#### **NOVA SCOTIA UTILITY AND REVIEW BOARD**

IN THE MATTER OF AN APPLICATION by MapleLNG LTD. ("MapleLNG") for a PERMIT TO CONSTRUCT a LIQUEFIED NATURAL GAS ("LNG") PLANT at Goldboro, Guysborough County, Nova Scotia

SCHEDULE "A" Individual Submissions and MapleLNG Responses

Subject: Application for Permit to Construct – Response to Public Comments

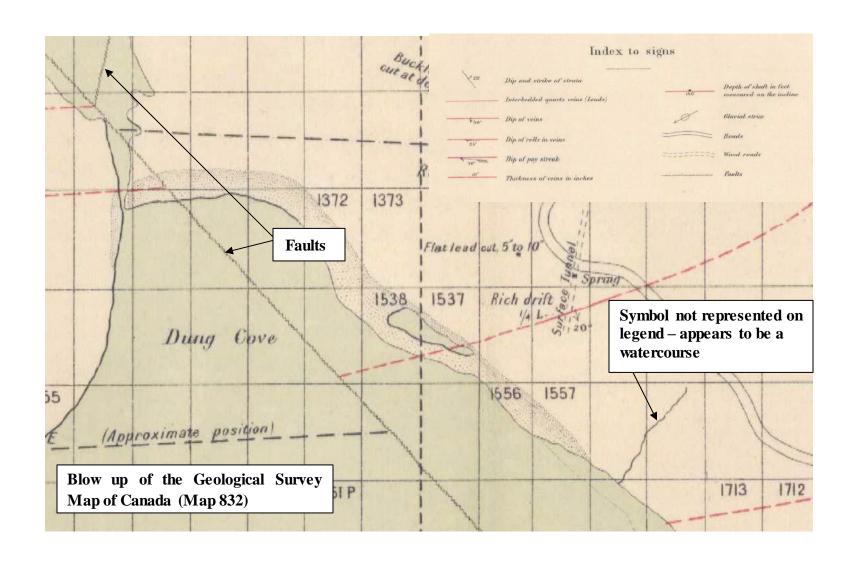
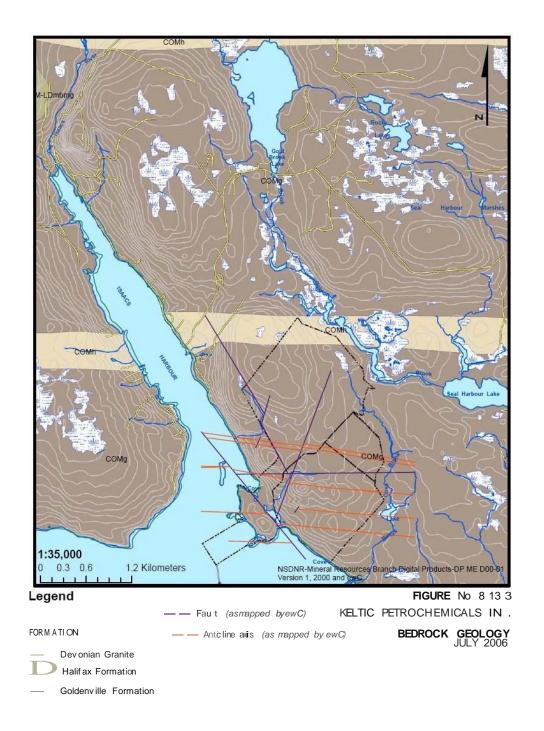
The area of the proposed LNG has been extensively used for Gold mining since 1868 and has very detailed maps and research of the Geological Faults that are known to exist and can be found by accessing the Natural Resources website or library. What I find very disturbing is that after comparing Maples site plan with the geology of the area it appears that they intend to construct their Pipeline and one of their storage tanks directly on top of these Geological Faults. After reviewing all of the submissions and evidence supplied by Maple I can not find any mention of these Faults in there geological exploration section in Volume 2 and none of their maps show any of the faults in the area.

Under the Pipeline Act-Pipeline Regulations (Nova Scotia) section 16 (a) states [A Bulk plant or storage facility shall (b) be located in an area that is known to be free from flooding, landslides, rock falls, and geological faults.] Given that the Act clearly prohibits their project from being built in this area the board must clearly reject Maples application for its Permit To Construct their LNG at Goldboro.

I will be sending some of the evidence with this letter to verify my research along with a section of a map from the Geological Survey of Canada (G S C Map 832) showing the location of the Geological Faults in relation of Maples infrastructure. Also included are 2 pages from the Geological Survey of Canada (MEMOIR 385) (GOLD FIELDS OF NOVA SCOTIA) that provide details of the known geology in the Issac Harbour gold district, that area of the proposed project. The Department of Natural Resources has compiled a great deal of information dealing with this area due to it being one of the largest gold producers in Nova Scotia and have stated in their report (EASTERN SHORE COMPILATION PROJECT) that (LOCAL FAULTS ARE FOUND IN ALL GOLD DISTRICTS) and specifically refer to Isaacs Harbour, (sheets included with submissions).

The MapleLNG provincial EA described the available seismic information and mapping of fault locations (See attached EA Figure 8.13-3 and text from EA Sections 8 and 9). This information was summarized in the permit to construct submission Volume 3, Section 3b (Design Seismic Data – 2.3 page 8). MapleLNG recognizes further seismic work is required and will be proceeding with a seismic hazard risk assessment as indicated in the above paragraph. Based on the provincial EA, earthquakes are considered to have little if any effect on the proposed plant site.

Also, regarding the reported fault located beneath one of the LNG storage tanks as depicted and circled on the geological mapping figure on page 3 of the public submission, Maple has reviewed an original copy of the same mapping as well as mapping prepared by professional geologists for the provincial EA and conclude that the LNG tanks do not overlie geological faults (See attached Figure 8.13-3 from the Provincial EA and an original copy of the Geological Survey Map of Canada (Map 832)).

Notwithstanding Nova Scotia's location within the stable continental part of the North American tectonic Plate, within Canada's eastern seismic region, large earthquakes have occurred in the past and will inevitably occur in the future. These are likely to have little effect, if any, on the proposed plant site only and may (or may not) occur at any time during its construction and/or operation. Tanks and other structures on site will be designed for the seismic rating in the region, as required under CSA Z276-01. In addition, all structures at the site will be built to meet or exceed the new design criteria as set out in the 2005 edition of the NBCC. Appropriate contingency planning will also address the possibility of structural failure which may result from such an event. With proper mitigation measures in place, the residual effects, although improbable are expected to be of major significance (see Table 11.0-1 in Section 11.0). Considerations for mitigation are presented in Section 10.

Figures 9.22-1 to 9.22-5 contain the new seismic hazard maps that will be used in the 2005 edition of the NBCC to replace the 1985 maps presently in use in the 1995 NBCC (Adams and Atkinson, 2003). The 2005 edition of the NBCC was adopted by Nova Scotia on May 1, 2006 (T. Ross, pers. comm., 2006). The 2005 edition of the NBCC contains significant changes in the provisions for seismic loading and design (Heidebrecht, 2003). The 1995 NBCC employed seven "zones" (0 to 6) to describe peak ground velocity and acceleration, determined at a probability of 10% in 50 years. In the 2005 edition of the NBCC, the Geological Survey of Canada is now using a probability of exceedance of 2% in 50 years, and calculating hazard in the form of uniform hazard spectra, which provides a much better period-dependent representation of earthquake effects on structures. The implication is that the design forces in short-period structures relative to those in long-period structures would be much larger than is the case for structures designed in accordance with the 1995 NBCC provisions.

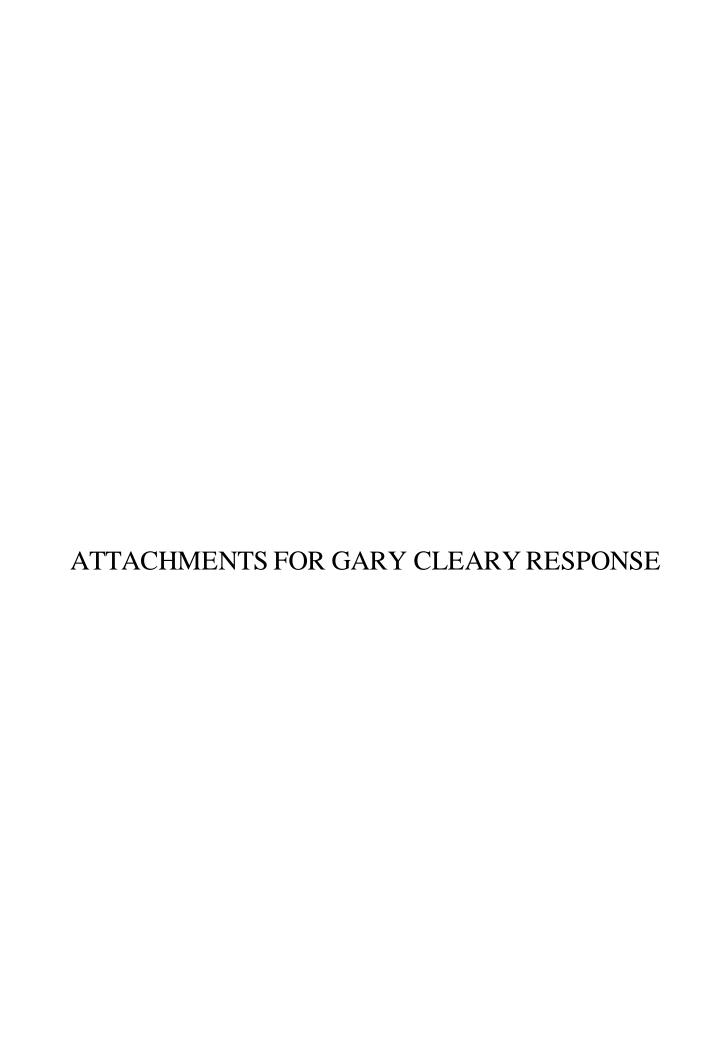
6. The conceptual design dose not appear to address concerns related to potential significant rise of sea level on marine facilities.

As per the attached figure, the minimum elevation of the structure is CD+8.62 m. For the trestle, the lowest level of the superstructure is chosen at CD+9.00 m and for the loading platform, the lowest level is CD+10.35 m. Considering a sea level rise of 0.60 m, the elevation of the loading platform is still sufficient; see attached Drawing 0381-004: Typical Cross Sections and Side Views.

The trestle cross beams slope up at the underside (see attached Drawing 0381-004) leaving a small area of exposed concrete. The additional load due to wave crests contacting the concrete cross beam support is small compared to the total wave load. As the ice load is significant higher than the wave load on a pile, there is ample safety left for wave conditions (overall safety factor of approximately 5.0) and therefore some additional load on the underside of the concrete cross beam will have no effect.
